The Commission has issued the enclosed Amendment No.32 to Facility Operating License No. NPF-30 for the Callaway Plant, Unit 1. This amendment is in response to your application dated December 15, 1987.

The amendment revises Technical Specification Figures 6.2-1 and 6.6-2 and Section 6.5.1 to reflect nuclear function organizational changes associated with the establishment of the positions of Manager, Licensing and Fuels, and Assistant Manager, Work Control, and the elimination of the Assistant Manager, Support Services, position and the resulting changes in the operating organization, engineering organization and On-Site Review Committee.

Amendment No.32
License No. NPF-30

SAFETY EVALUATION BY THE OFFICE OF NUCLEAR REACTOR REGULATION
RELATED TO AMENDMENT NO. 32 TO FACILITY OPERATING LICENSE NO. NPF-30

FIGURE 6.2-1
OFFSITE ORGANIZATION

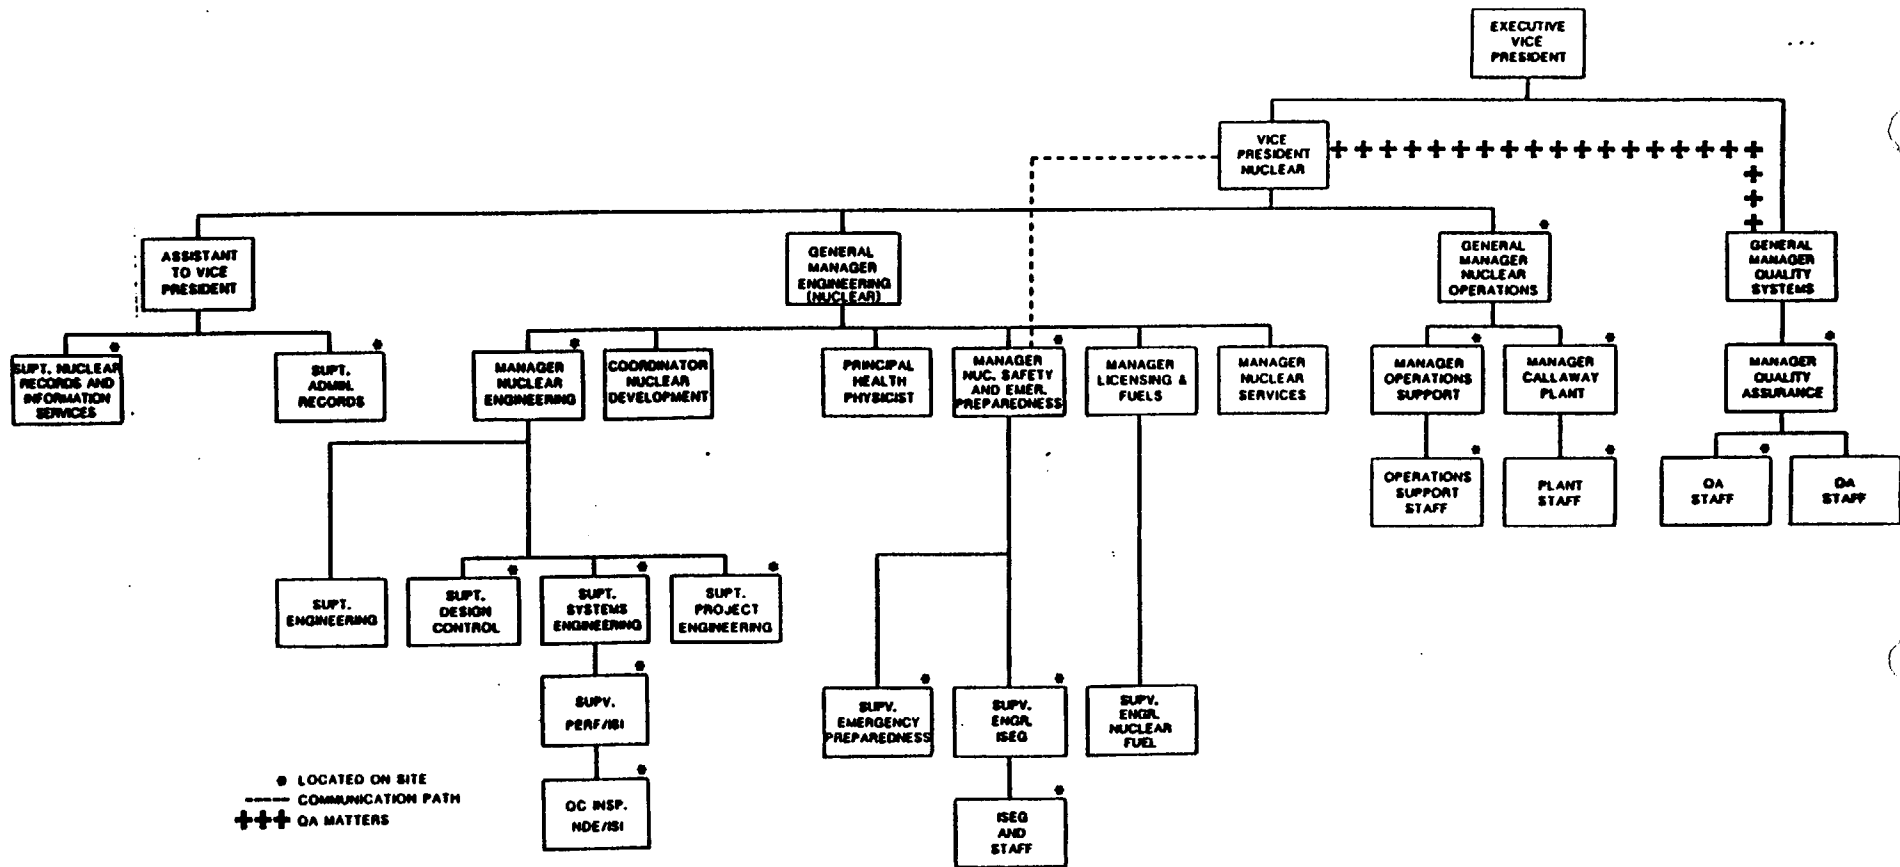
2.1 Figure 6.2-1, Offsite Organization, would be revised to:

- (1) Consolidate the Licensing and Fuels Department under the newly created position, Manager, Licensing and Fuels. This consolidated department reports directly to the General Manager, Engineering.

- (2) The Manager, Nuclear Engineering, position is now located at the Callaway Site.
- (3) The Assistant Manager, Nuclear Engineering, position is eliminated and the Superintendent, Design Control, and the Superintendent, Systems Engineering, report directly to the Manager, Nuclear Engineering.

- (4) A new position, Superintendent, Project Engineering, is established which will report directly to the Manager, Nuclear Engineering.
- (5) Quality Control (QC) inspectors, responsible for Non-Destructive Examination (NDE) and In-Service Inspection (ISI), will report through the Supervisor, Performance and ISI, to the Superintendent, Systems Engineering.

- (6) The Superintendent, Administration Services, will no longer report to the Assistant to the Vice President, but will report to the Manager, Operations Support. This change is also shown on revised Figure 6.2-2.

The staff finds that these changes will not reduce the level of engineering support or the experience base; however, they should provide for improved coordination of engineering support of plant operations. The revised offsite organization is in accordance with the guidance in Section 13.1.1 of the Standard Review Plan, NUREG-0800, and is acceptable.

FIGURE 6.2-2
UNIT ORGANIZATION

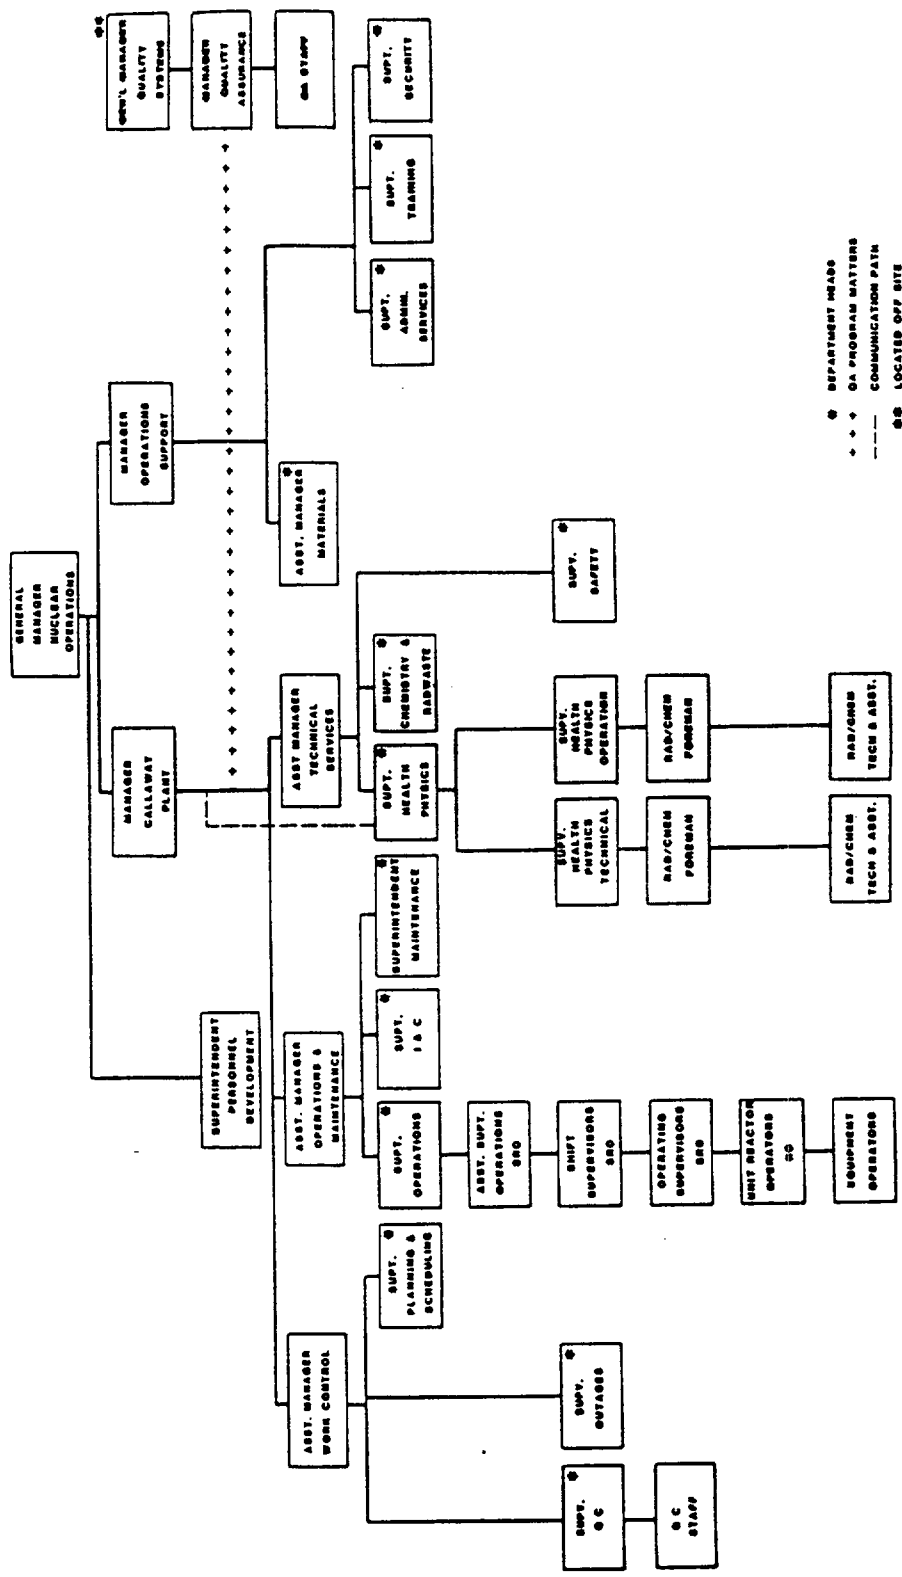
2.2 Figure 6.2-2, Unit Organization, is revised to:

- (1) Establish the position of Assistant Manager, Work Control, which reports to the Manager, Callaway Plant. Reporting to the Assistant Manager, Work Control, is the Superintendent, Planning and Scheduling, the Supervisor, Quality Control (QC), and the Supervisor, Outages. Consolidation of Planning and Scheduling with the Outages Department provides for enhanced coordination of plant testing and modification activities. The QC Department is being reassigned from the Compliance Department which is addressed below.

- (2) Consolidate the Chemistry and Radwaste organization under the Superintendent, Chemistry and Radwaste, which will continue to report to the Assistant Manager, Technical Services.

- (3) Establish the position of Supervisor, Safety, which reports to the Assistant Manager, Technical Services. This group addresses occupational safety and health issues, which were previously a responsibility of the Compliance Department.

- (4) The Assistant Manager, Support Services, position is eliminated and the Superintendent, Training, and the Superintendent, Security, report directly to the Manager, Operations Support.

- (5) As previously discussed regarding Figure 6.2-1, the Superintendent, Administration Services, reports to the Manager, Operations Support, rather than the Assistant to the Vice President.

- (6) The Compliance Department is eliminated, and its responsibilities are reassigned as follows:
 - (a) The Compliance Group reports to the Manager, Licensing and Fuels, as a Site Licensing Group.

- (b) The Quality Control group, responsible for plant modification/maintenance work, reports to the Assistant Manager, Work Control.
 - (c) The Quality Control personnel, responsible for NDE/ISI, report to Nuclear Engineering as discussed regarding Figure 6.2-1.

- (d) Surveillance Tracking is performed within Nuclear Operations.
- (e) Fire Protection reports to Nuclear Engineering.
- (f) Personnel Safety reports to the Assistant Manager, Technical Services, as previously discussed.

The staff finds that these changes will not reduce the level of operations, technical and maintenance support for the operation of Callaway plant. These changes should, however, improve interdepartmental responsiveness and efficiency. The revised unit organization is in accordance with the guidance in Sections 13.1.2-13.1.3 of the Standard Review Plan, NUREG-0800, and is acceptable.
